1 **Comment #39 D2.1**
2 **(TDL for comments #214 , #248, #304, #239 and #195 from D2.0)**

3
4 **From TDL List for comment #214 response and remedy + new issues:**

16
17 **Concept (Option 1)**

468 **5. Update the following PSE state diagram Figure 33-48**

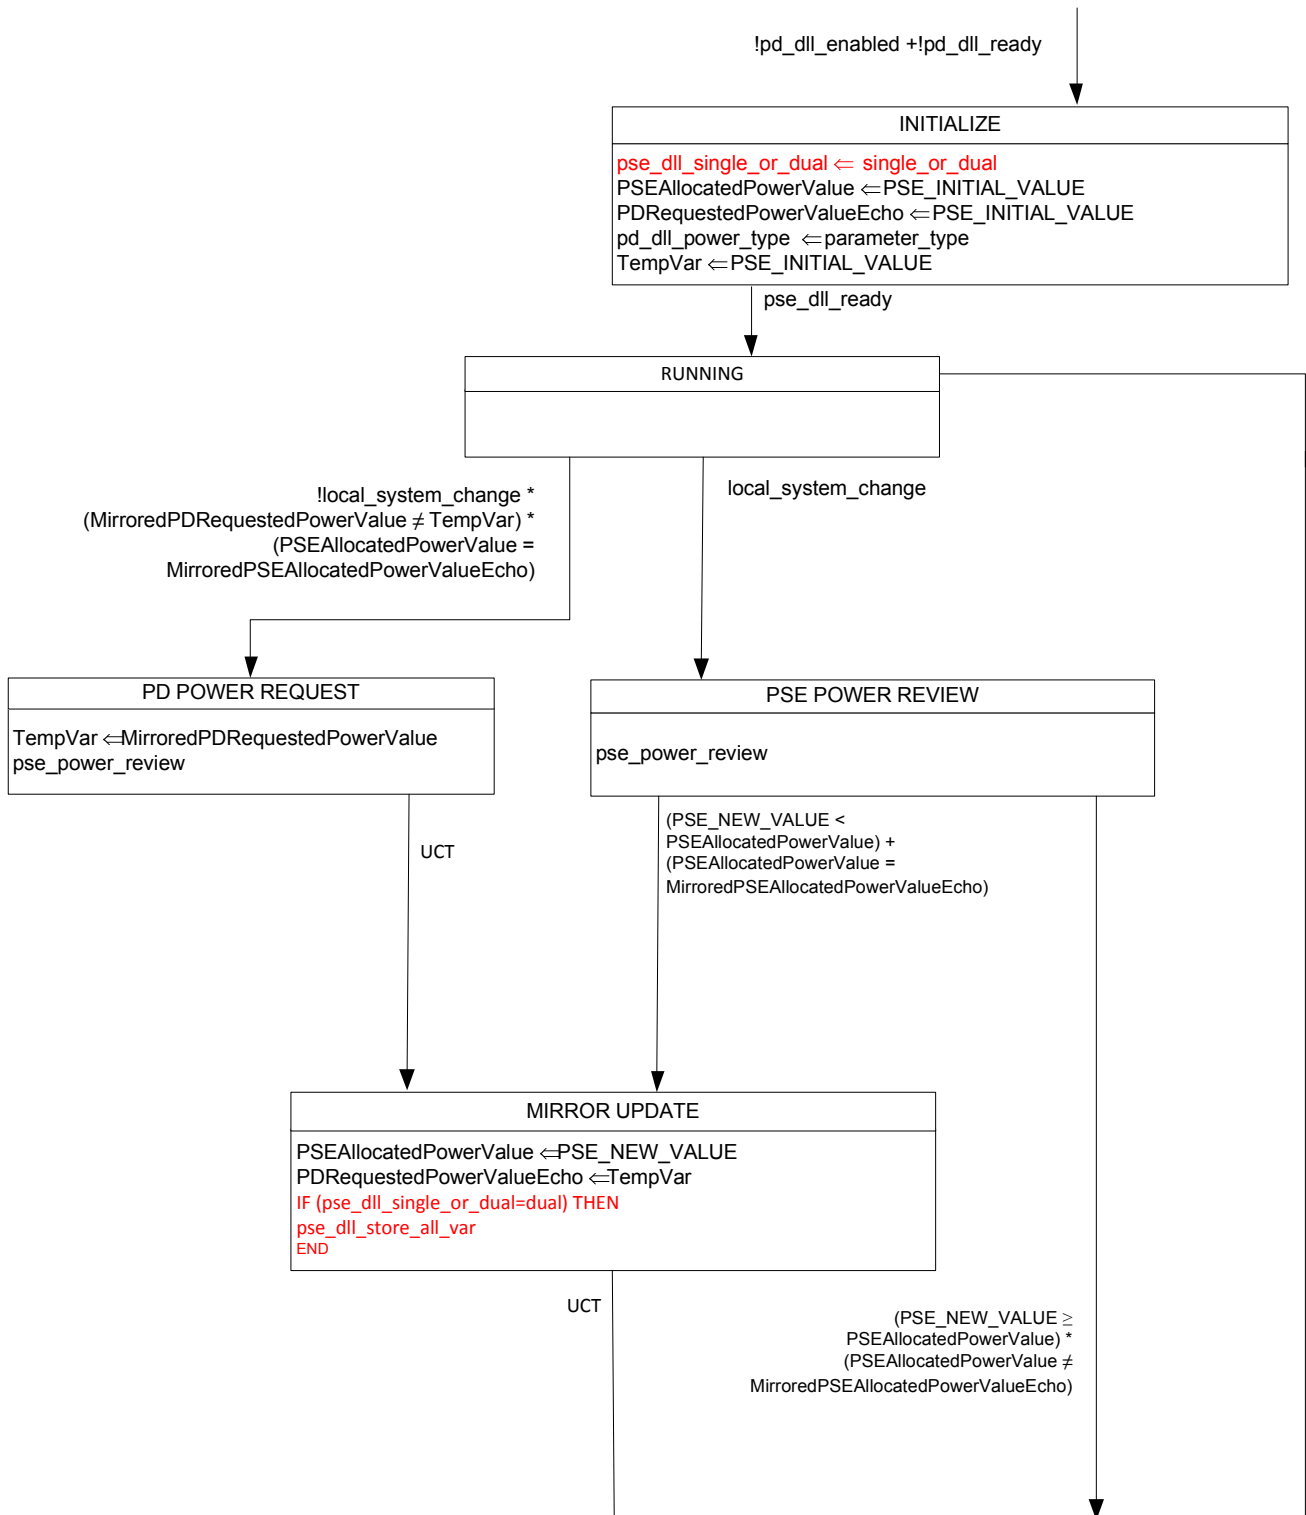
51 When the state machine done with updating the PDRequestedPowerValue and PSEAllocatedPowerValue for Mode A, all the other
52 state machine variables are stored in internal dll_XXX_modeA variables to be reused if needed by the state machine after the state
53 machine moved to work on ModeB.

54 When the state machine done with updating the PDRequestedPowerValue and PSEAllocatedPowerValue for Mode B, all the other
55 state machine variables are stored in internal dll_XXX_modeB variables to be reused if needed by the state machine after the state
56 machine moved to work on ModeB.

474 **6. Update the following PSE state diagram Figure 33-49**

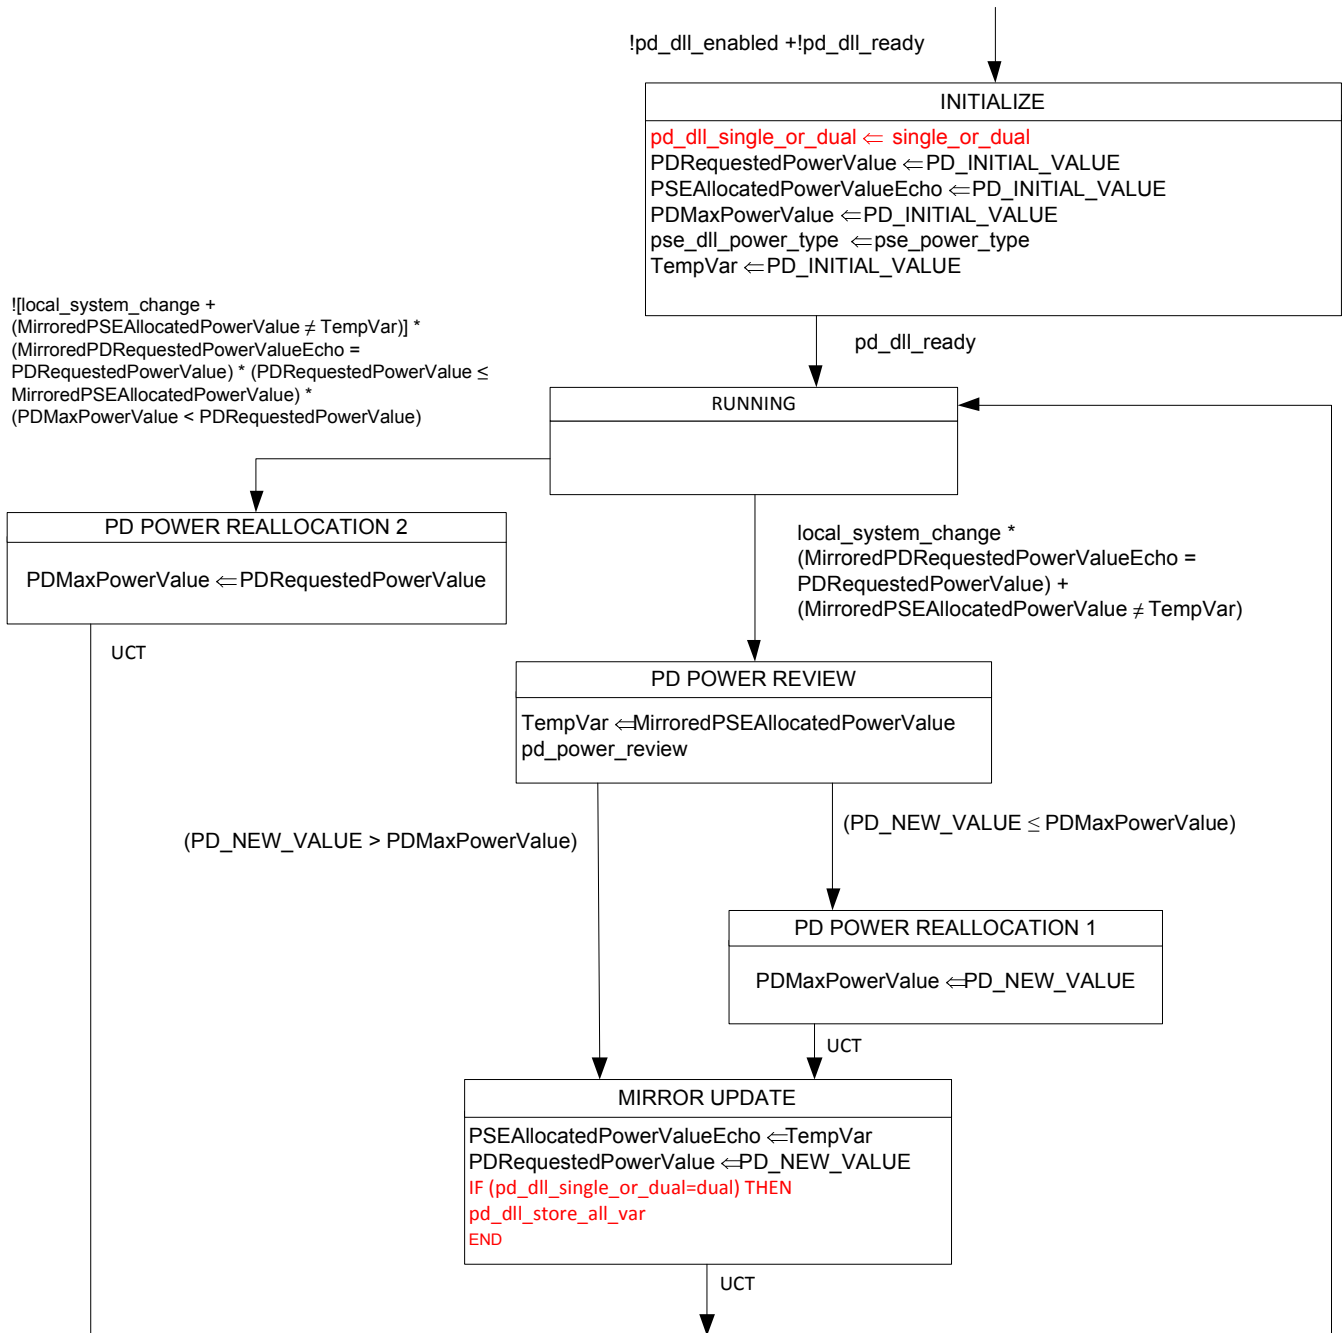
476 The general state change procedure for PDs is shown in Figure 33-49.
